E8663B-04

S E R V I C E N O T E

E8663B Analog Signal Generator

Intermittent power supply shutdown

Figure 1

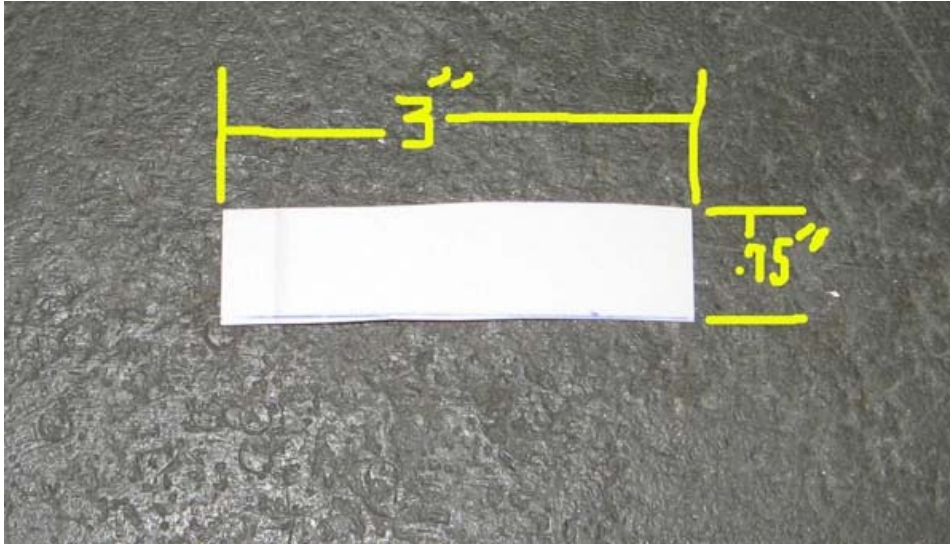
A via on the E8251-60441 mother board may intermittently short to the card cage causing the power supply to reset or shut down. The intermittent short does not cause permanent damage.

1. Remove the external cover using the procedure outlined in the service guide.
2. Position the instrument so the mother board is up. Loosen the 4 screws on the mother board stiffener shown in Figure 1.

9. Position the instrument so the mother board divider is visible and tighten the 4 screws that were loosened in Step 2 Figure 1. (Torque the T-10 screws to 9 in-lbs.)

Figure 3

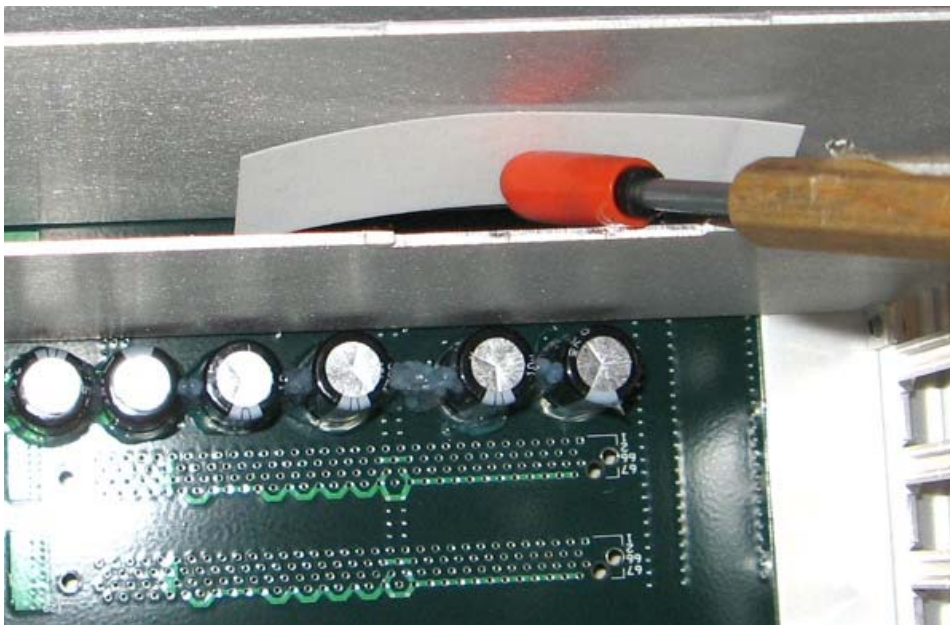
5. The next step is to slide the insulating material (sticky side up) between the card cage and the mother board. To position the insulating material, lightly attach it to a steel ruler or some other ESD safe item that can be used reach down into the tight space. Refer to Figure 3.

6. Start by placing the insulating material against the back wall (sticky side away from the wall) and then slide it down until the front edge of the strip is against the mother board. Once the front edge is against the mother board slide the insulator forward under the divider. If it does not want to slide forward under the divider lightly press down on the mother board near C435. Refer to Figure 3.

Figure 4

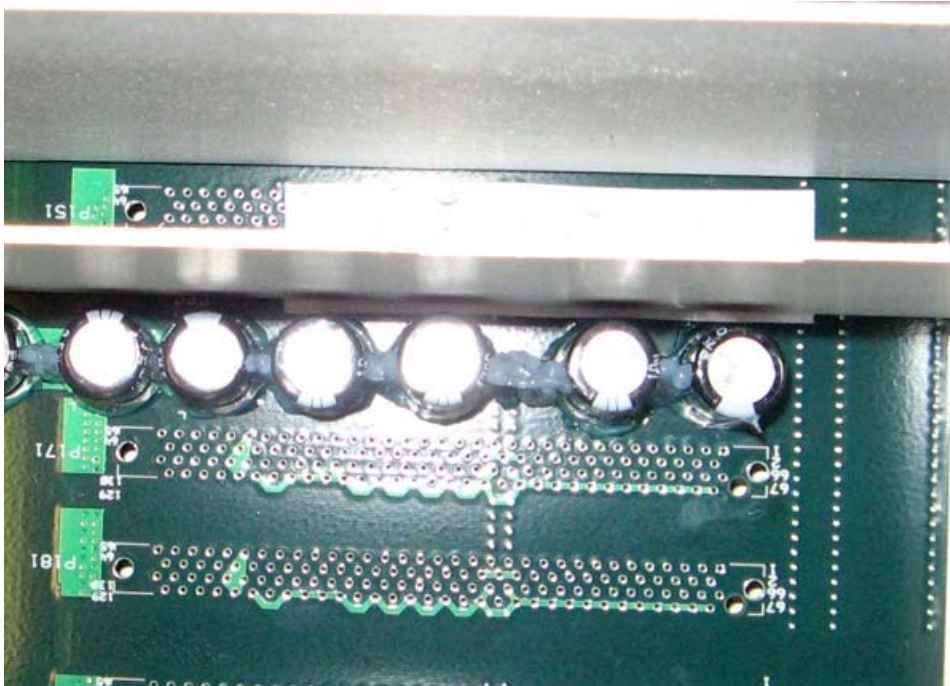
7. Position the insulator so that it can be seen on both sides of the divider and that it covers the area under the divider between the 4 larger capacitors on the right side as shown in Figure 4.

8. Once into place, press up on the bottom of the mother board to stick the insulator to the bottom of the divider and remove the tool.
